Appendix B3:

Municipal Correspondence (Letters/Email)

Re: Kingston LP (Samsung Renewable) – Proposed Landscape Plan

**Re: Landscaping Plan Comments
Sol-luce Kingston
Our File No.: D05-001-2011**

BUFFER PLAN PROPERTY 12

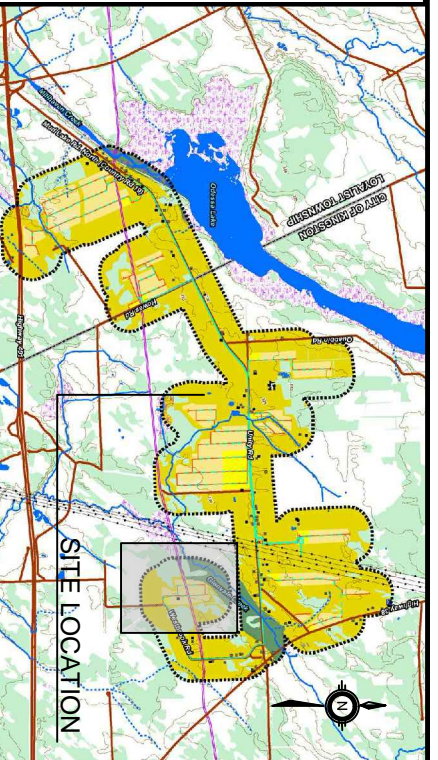
- Kingston Solar LP has indicated that property 11A is owned by a participating land owner. Please revise your drawing to reflect this.
- The setback to the south and east fencing along the Property 12 facility are not indicated, but are shown at less than 20m from Westbrook Road and the property line.

- Please clarify the type of visual buffer to be used along the southern fencing of Property 12. This visual buffer should extend to the southeast corner.

- Drawing L1 (Property 1) – Additional buffer planting is requested along fence lines that border the watercourse to increase the visual attenuation.
- Drawing L5 (Property 12) – Would like to see a vegetative buffer at the bend on Westbrook Road at the southeast corner of the proposed cell placement.
